STORM WATER REPORT

Cobey Creek Mixed Use Development Lee's Summit, MO

Condensed Version
October, 2020

Addendum 2

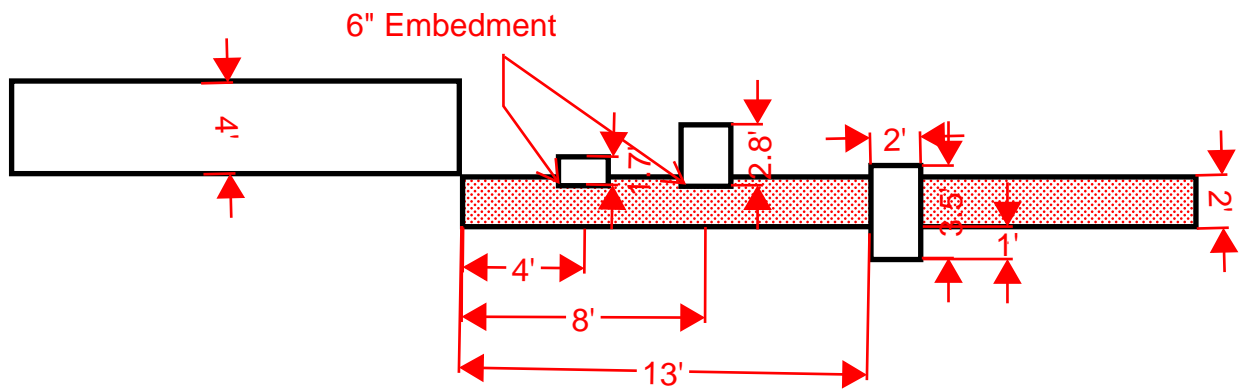
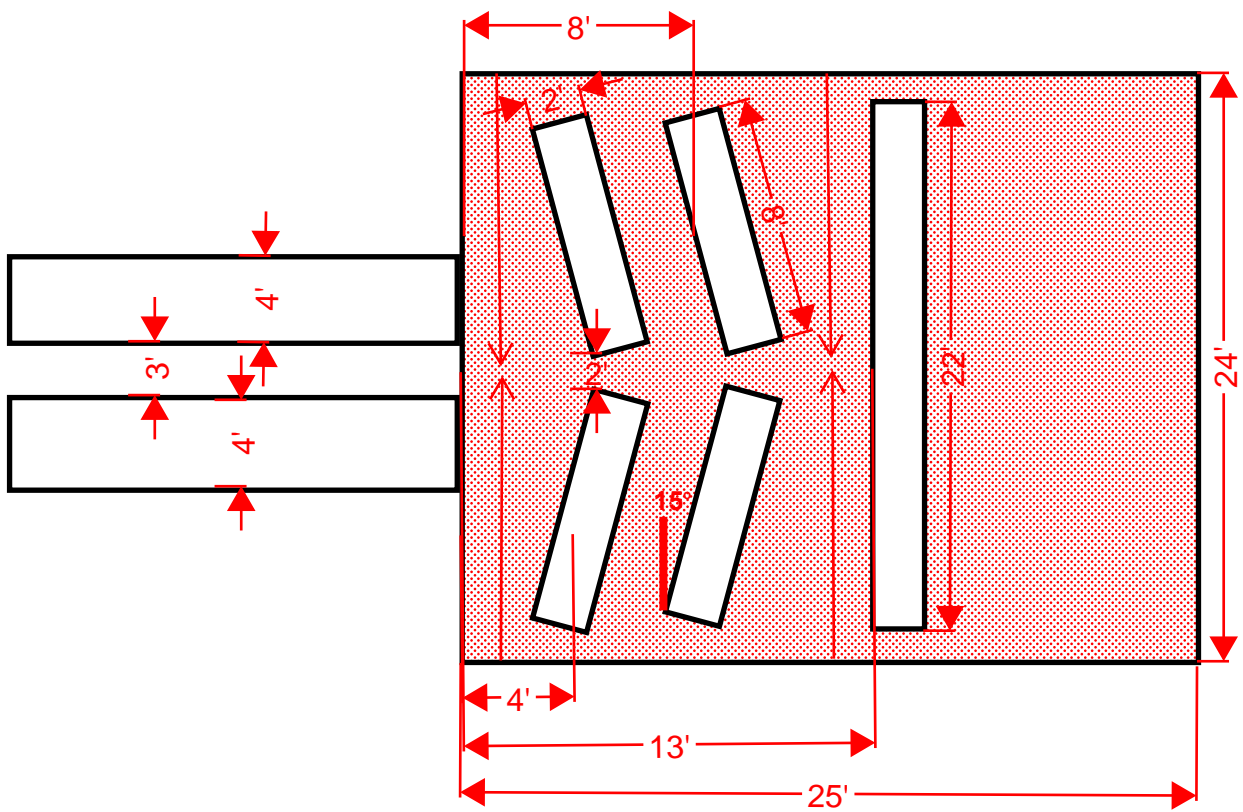
Additional energy dissipation has been added to the outlet structure at the request of the City of Lee's Summit. The outlet rip rap pad is fitted with a Contra Costa Design from HEC 14. The design details are included in the plans. The original 100-year outlet velocity is ~12.0 ft/s and the proposed 100-year outlet velocity is expected to be ~8.7 ft/s. Calculations are included in this Addendum.

Exit Velocity (VB=VC)	8.653	ft/s
First Baffle		
Height (H1)	1.174	ft
Width (WB)	8.000	ft
Space (L1)	4.111	ft
Second Baffle		
Height (H2)	2.349	ft
Width (WB)	8.000	ft
Space (L2)	8.221	ft
End Sill		
Height (H3)	0.479	ft
Top Width (W3)	8.000	ft
Location (L3)	13.152	ft
